September 17, 2024

Project No: 100200.32

**ADDENDUM NO. 3
TO THE CONTRACT DOCUMENTS AND DRAWINGS**

**For the construction of the
Aloe Bay Water Quality Enhancement Wastewater Treatment Facility**

FILE	SEE LEFT
VERIFY SCALE	
DATE	AUGUST 2024
PROJ.	100200.32
DWG.	A-14.0

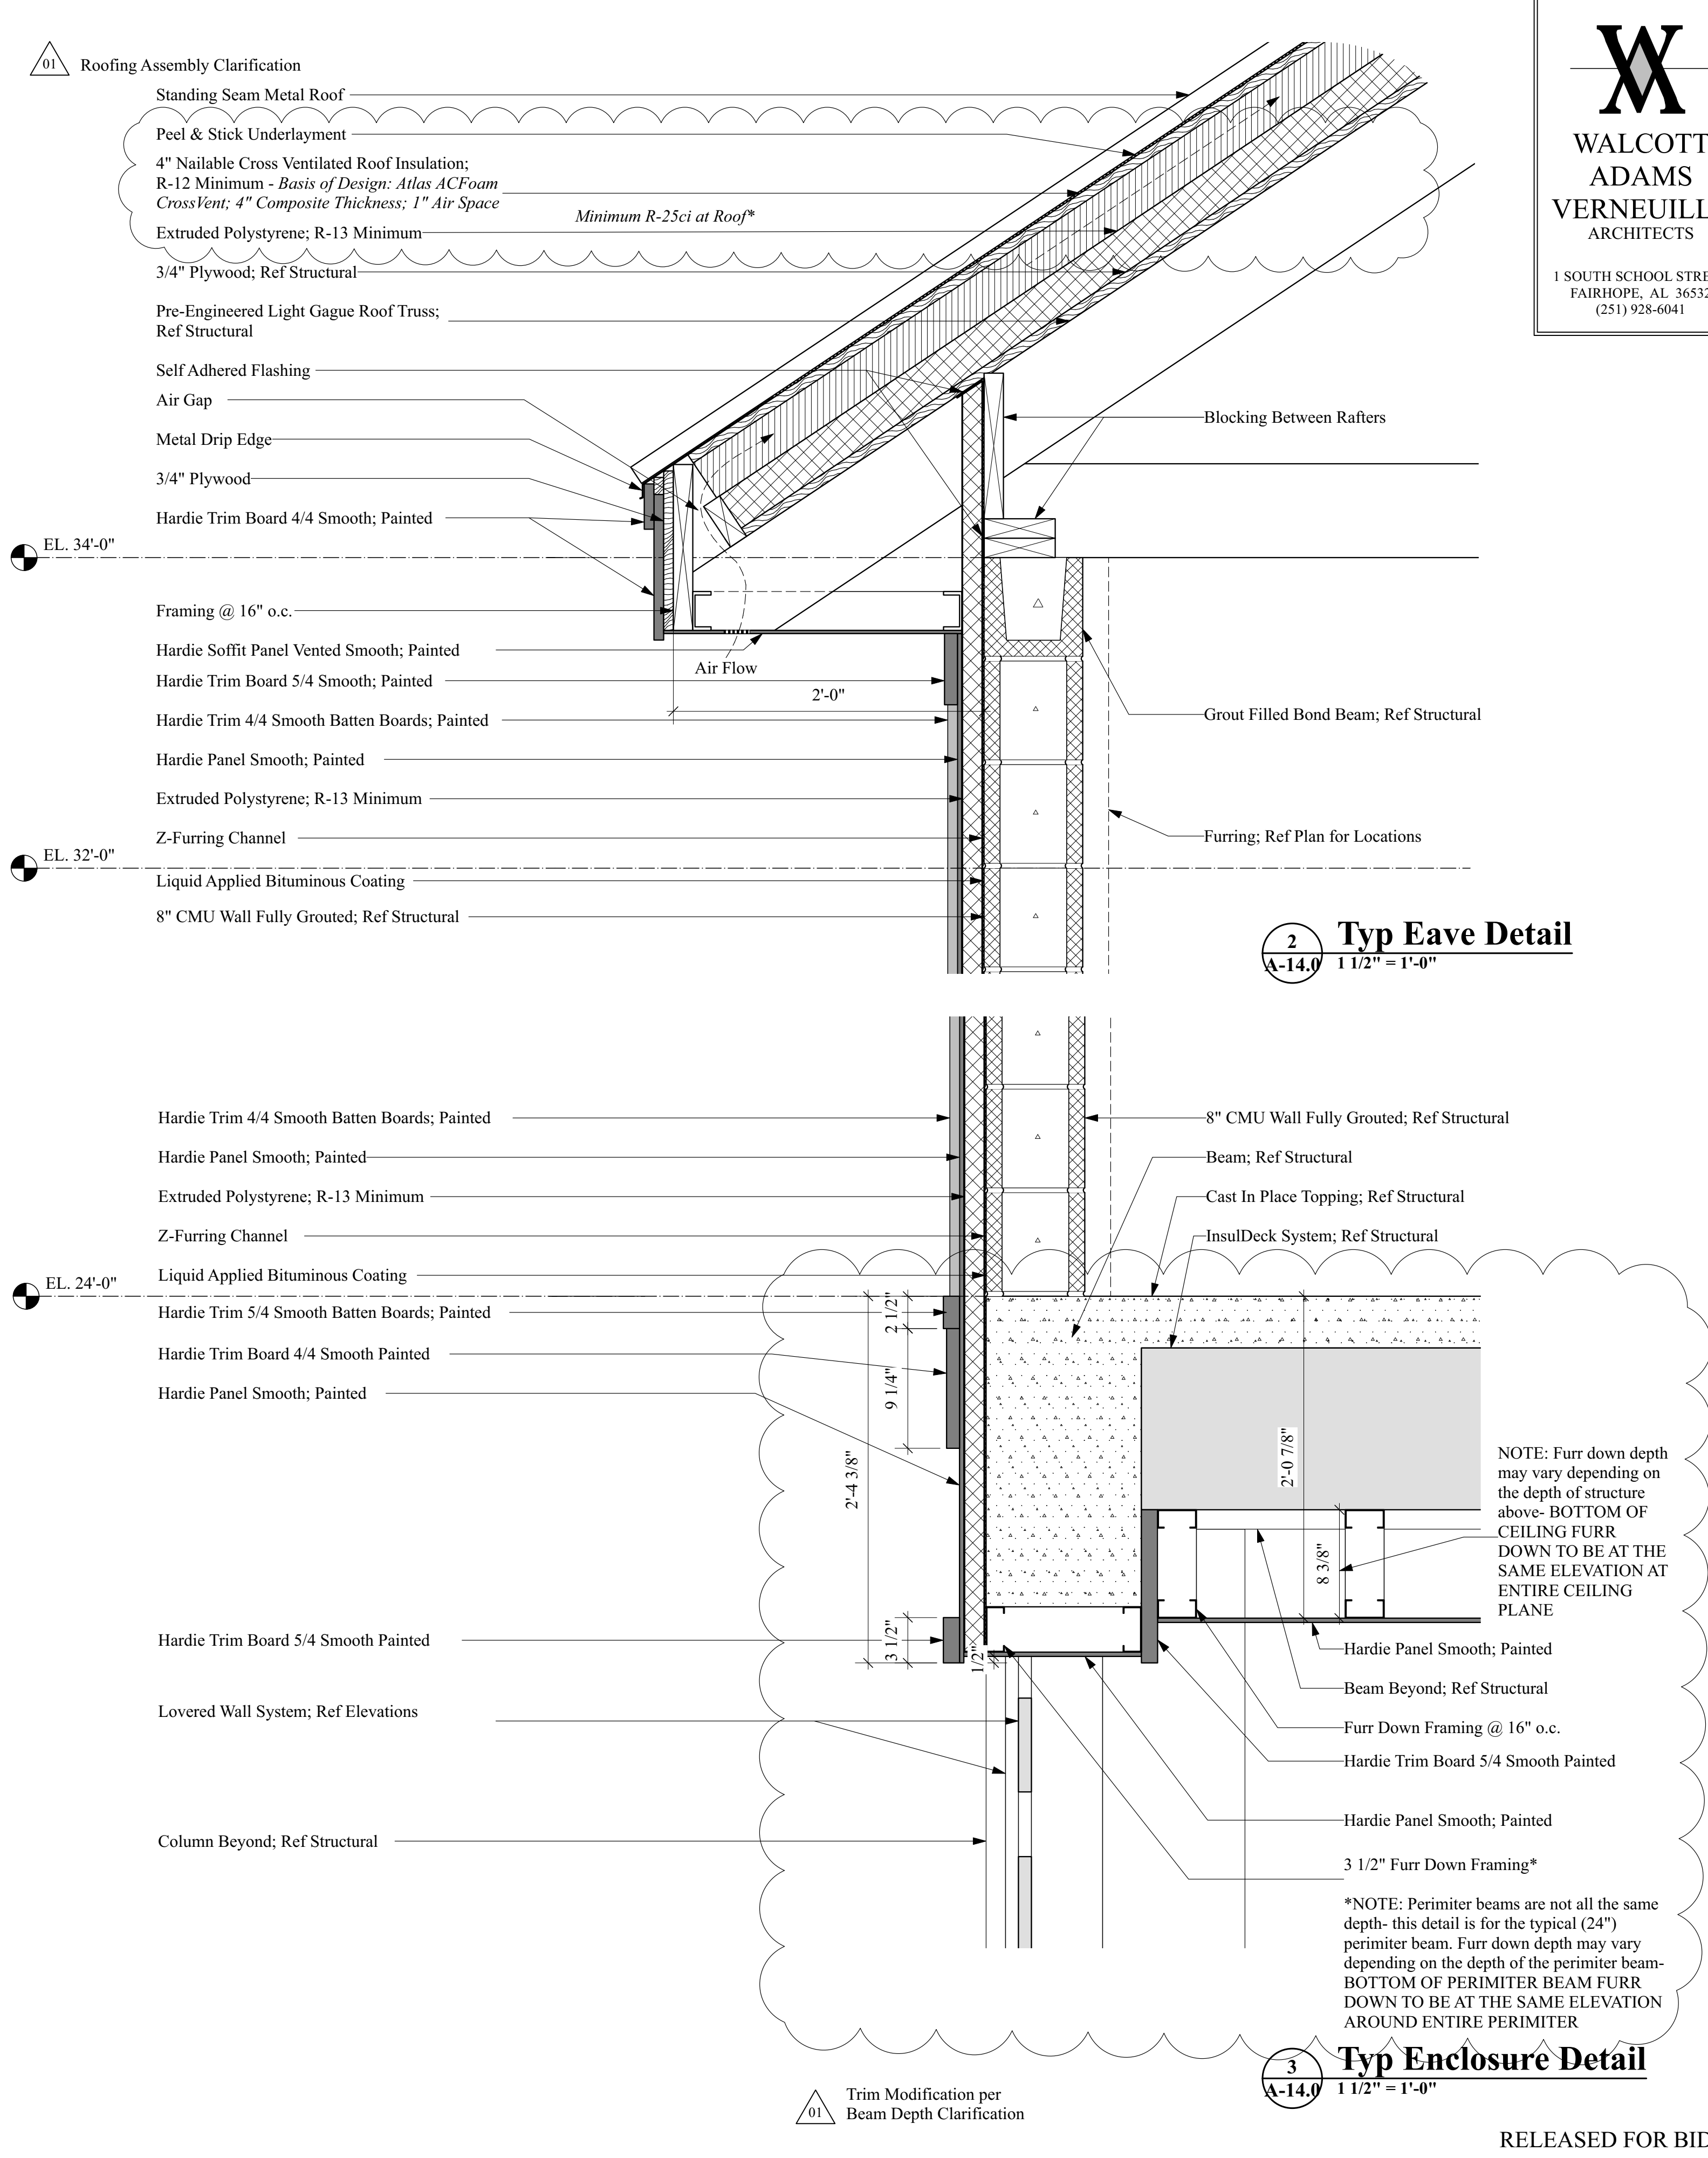
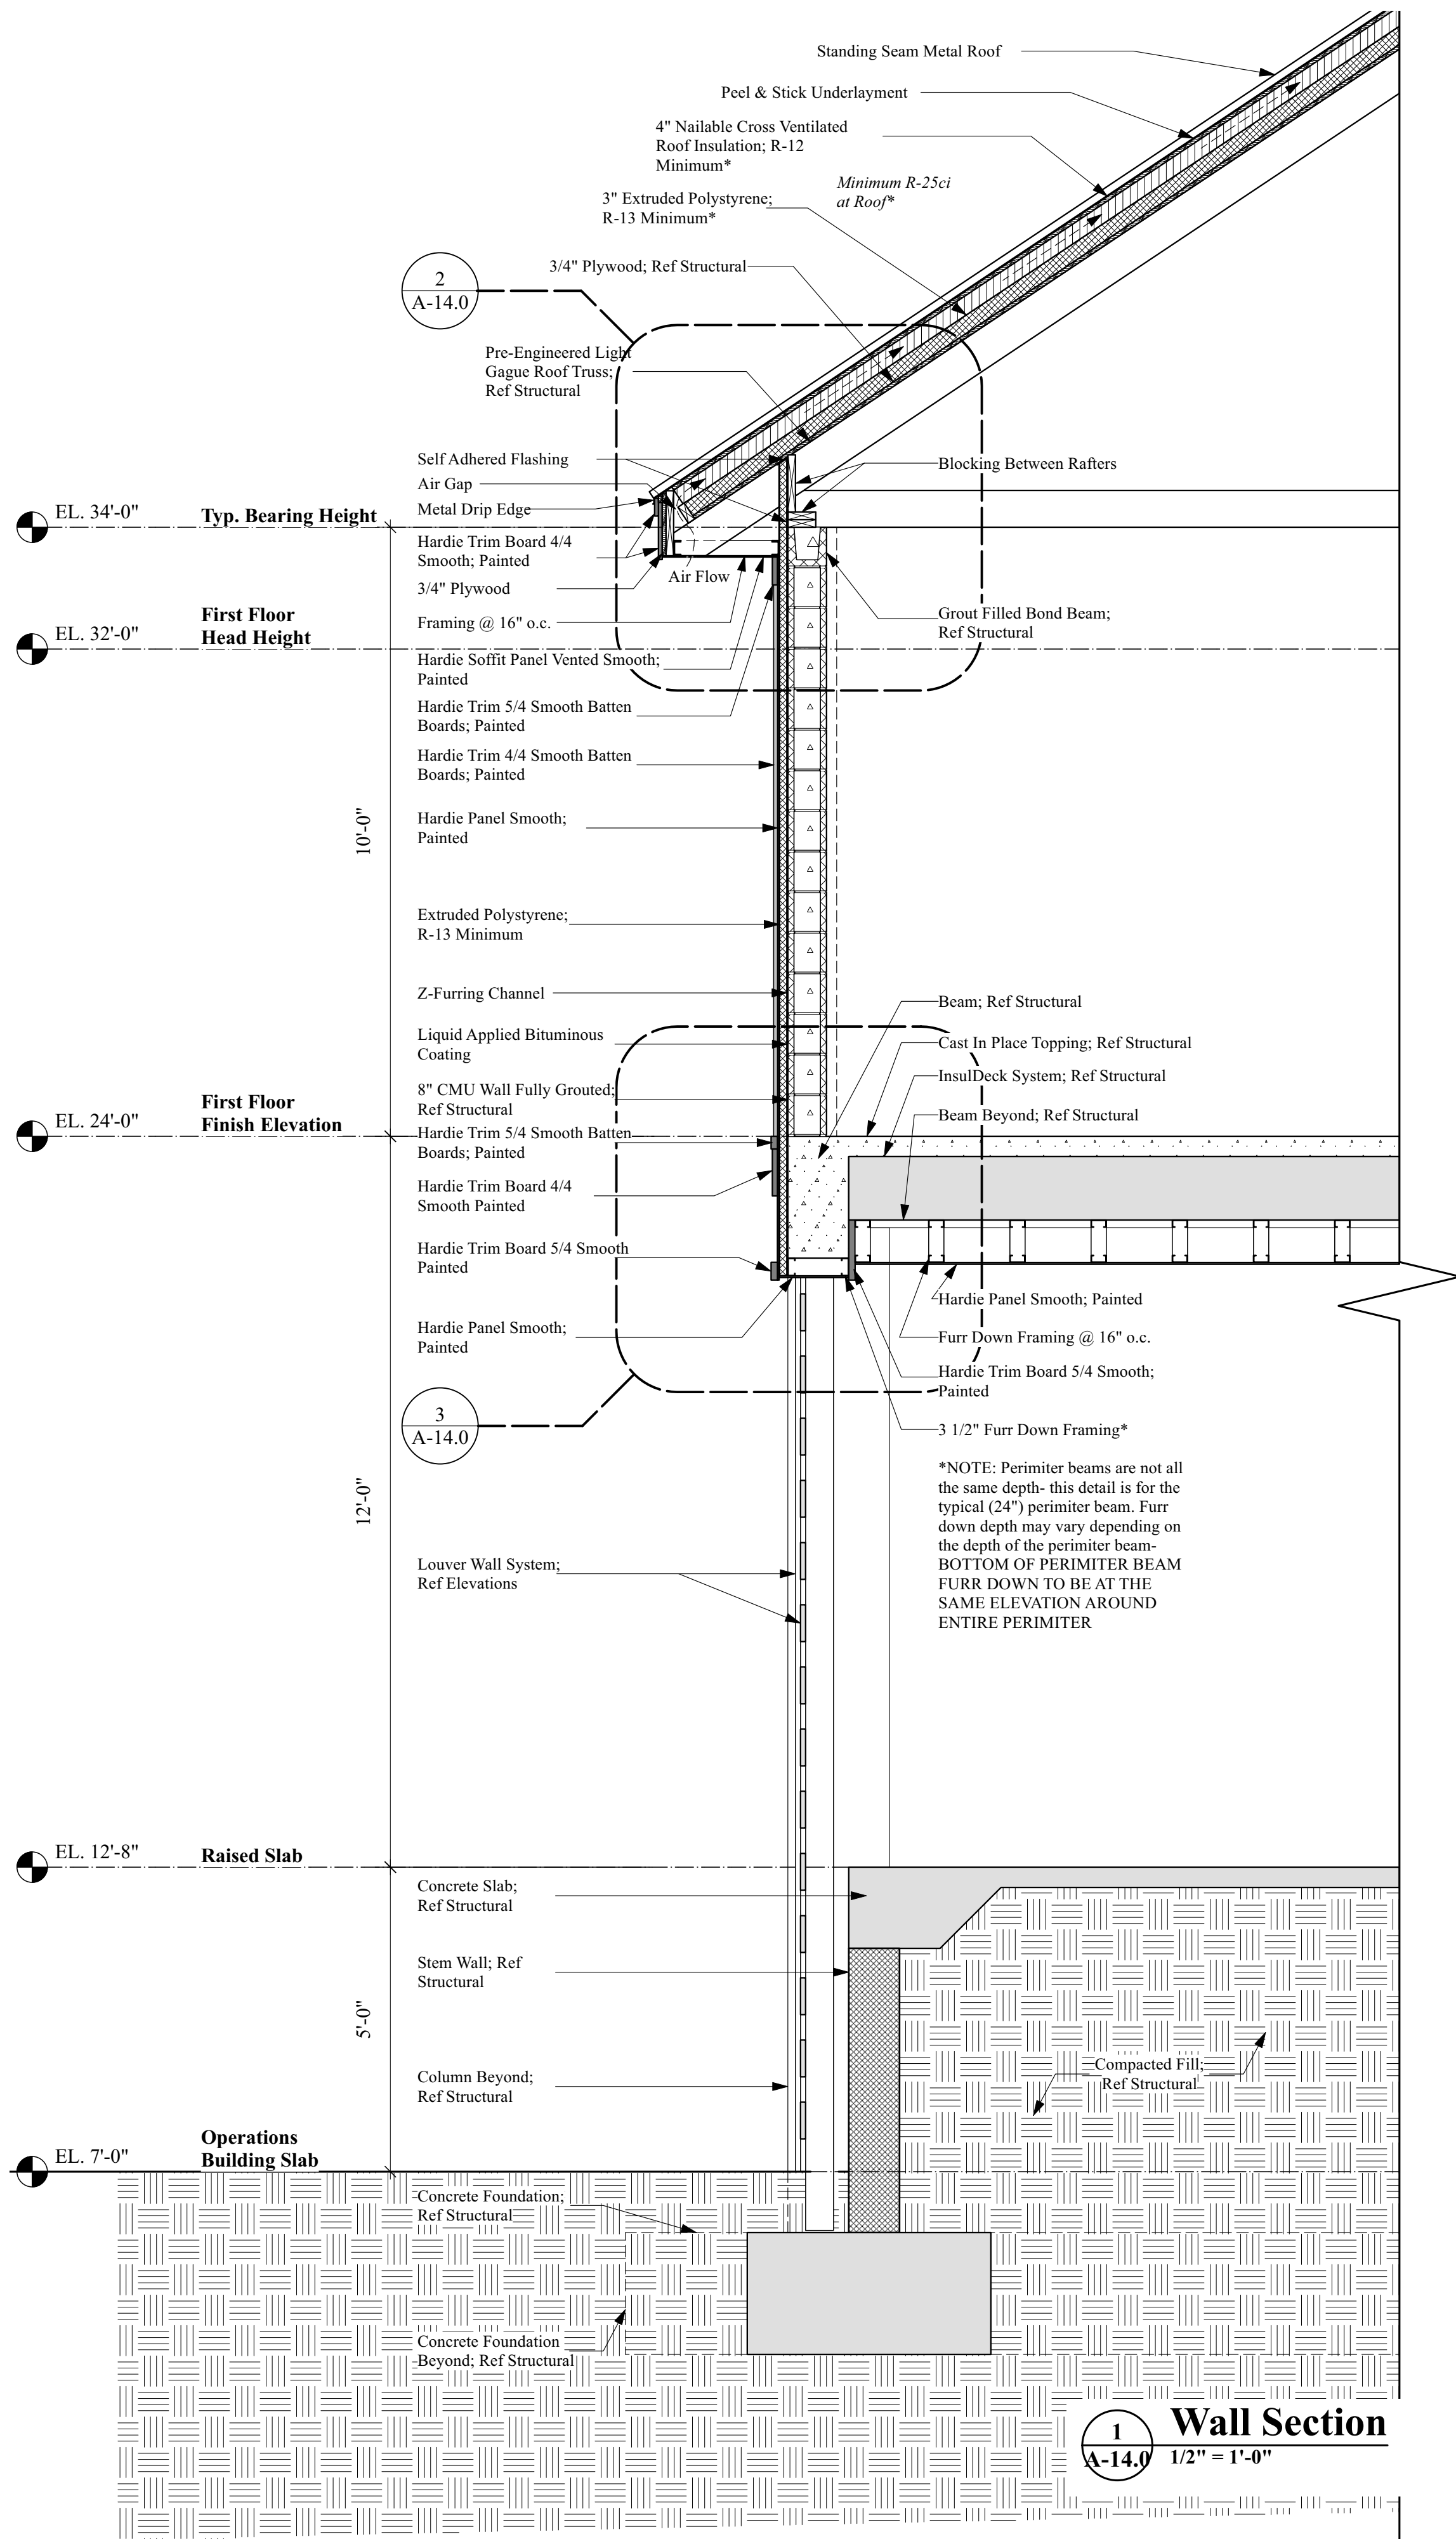
3. The concrete beam schedule on S-9.3 callout a few beams that have a large depth. This depth will most likely protrude lower than the 7 1/8" furr down framing shown in detail 3 on A-14.0. Is this acceptable to the architect, or should a deeper furr down be provided such that no beams are seen?

4. For the roof deck insulation, what products and thickness are required? We don't see any SPECS for this.

5. Where is the Ice and Water underlayment to be installed? It lists multiple layers.

Some of the deeper interior beam heights have been modified. Refer to revised Architectural sheets.

The basis of design is Atlas ACFoam Crossvent with a 4-inch composite thickness and 1-inch of airspace. Refer to revised sheet A-14.0.

Refer to revised sheet A-14.0.

FILE	SEE LEFT
VERIFY SCALE	BAR IS ONE INCH ON ORIGINAL DRAWING
DATE	AUGUST 2024
PROJ.	100200.32
DWG.	A-15.0

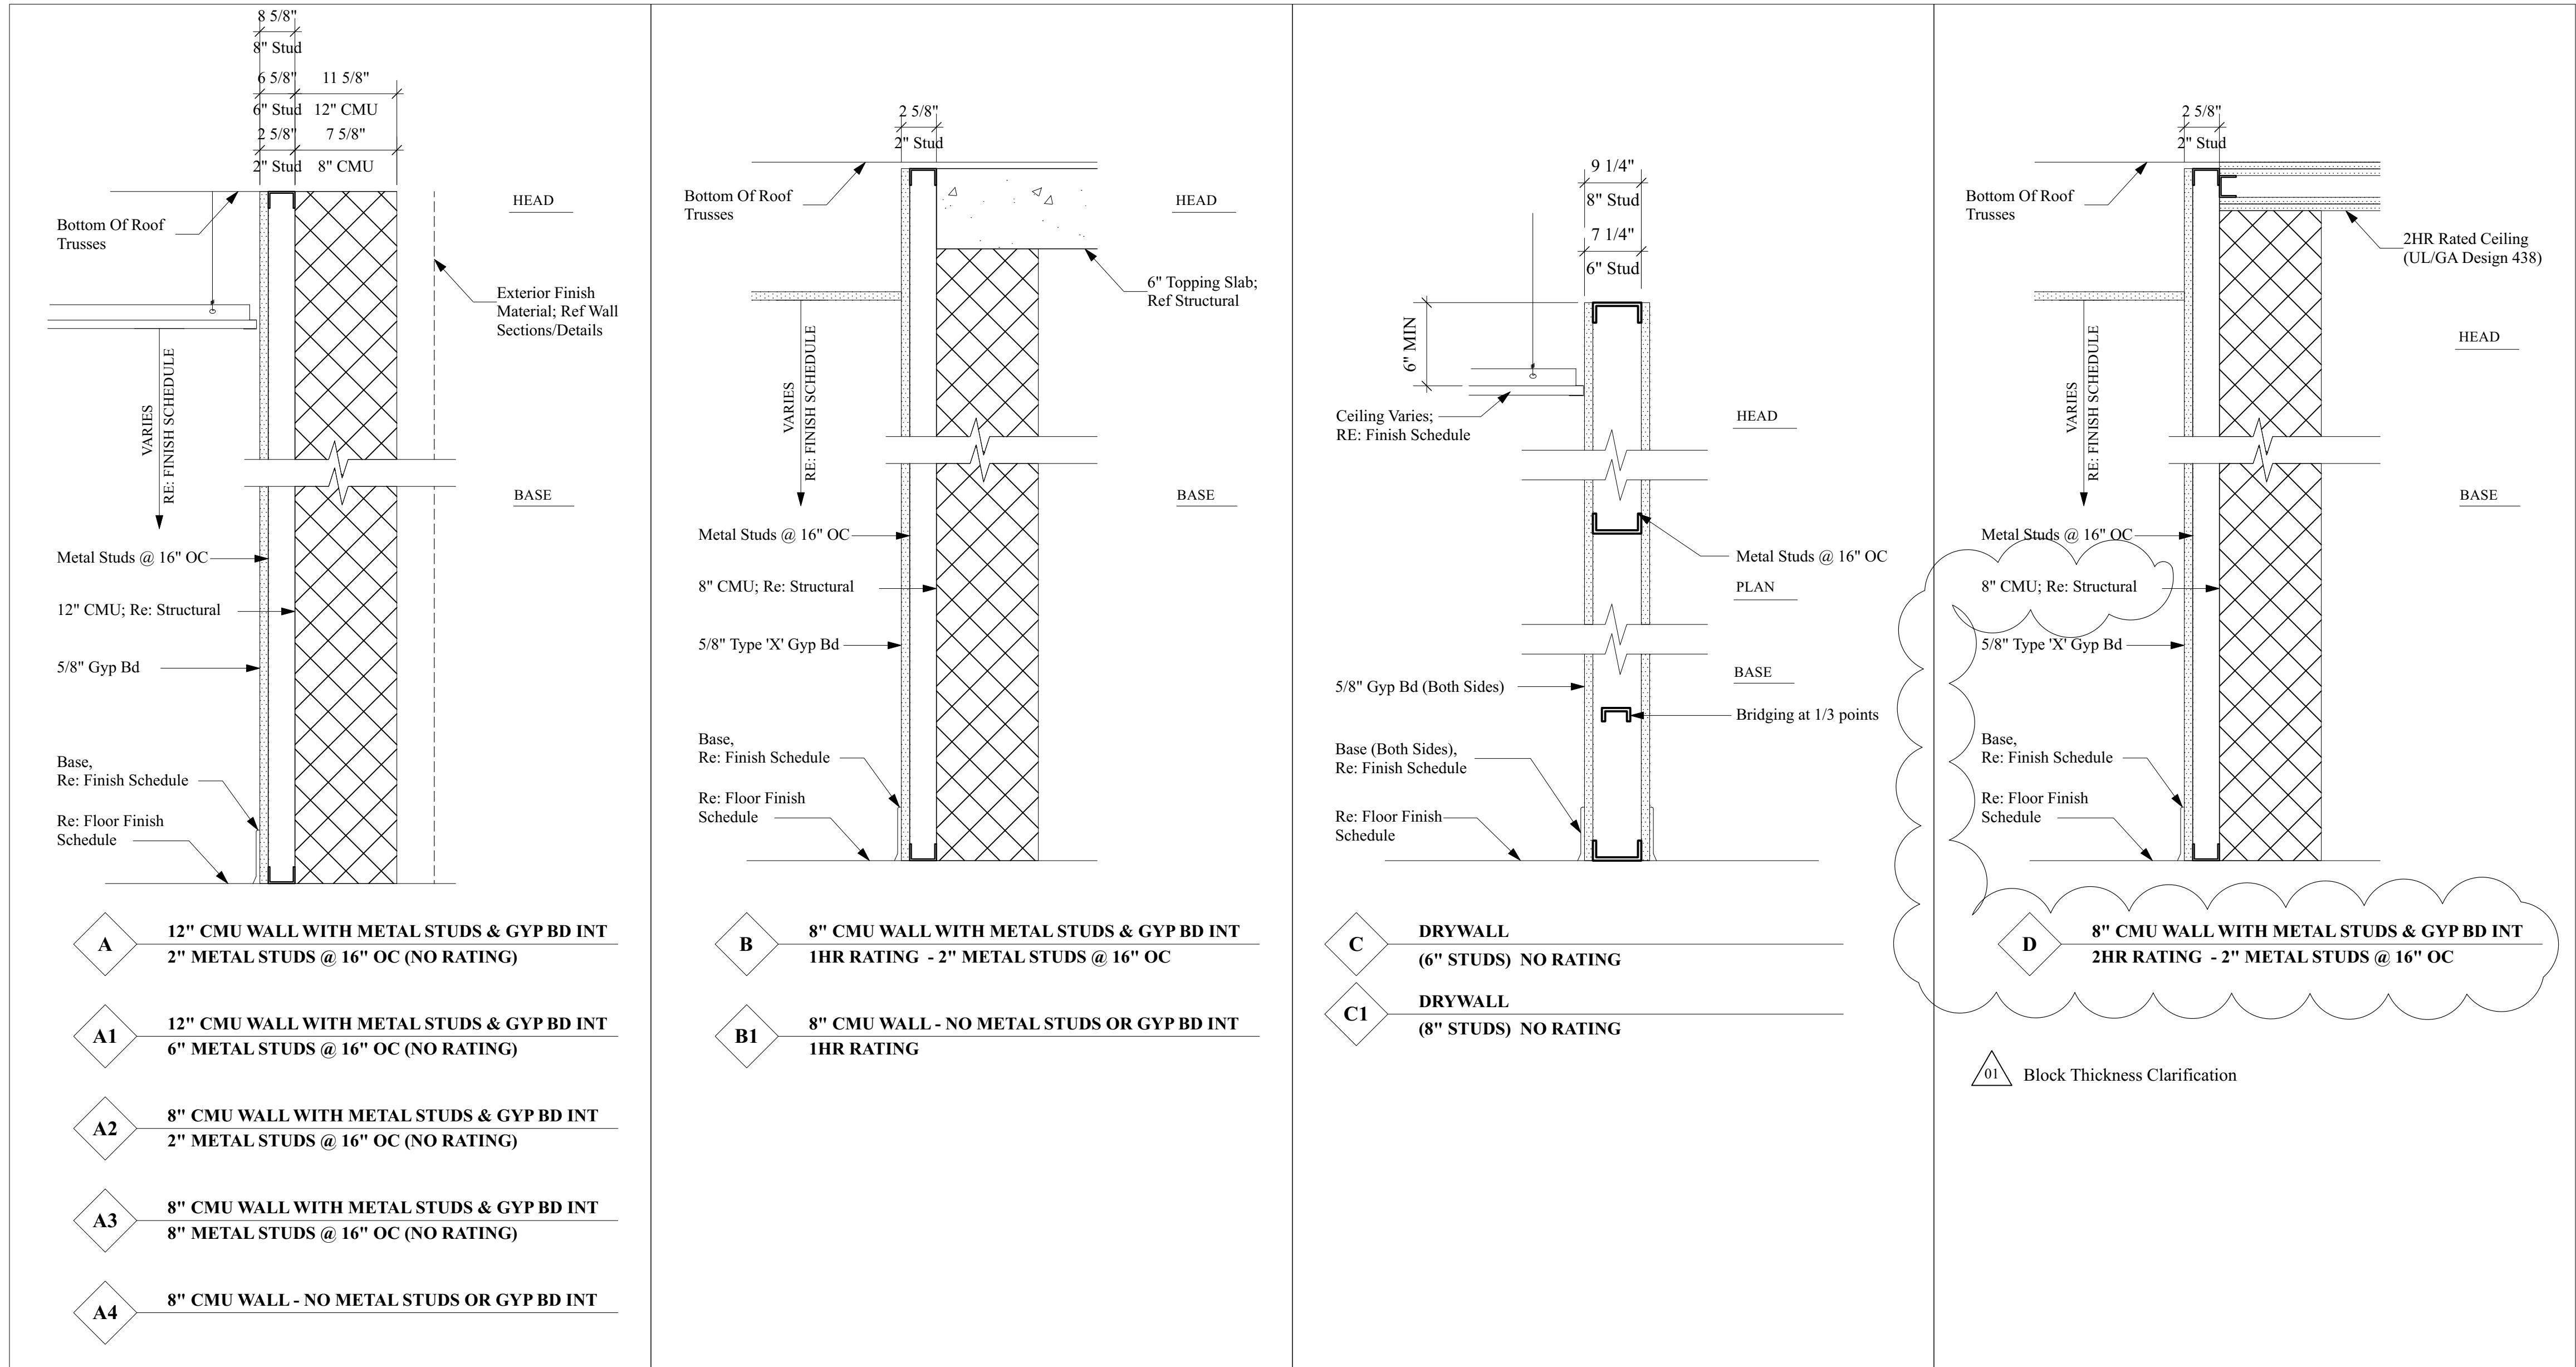
8. Regarding the Electrical Room CMU walls on the first floor, sheet A-2.0 calls out wall type D, which is 12" CMU according to the details on sheet A-15.0. Although, on sheet A-2.0 it looks like 8" CMU.

Sheet A-15.0 was updated to show 8-inch CMU wall. Refer to revised sheet A-15.0
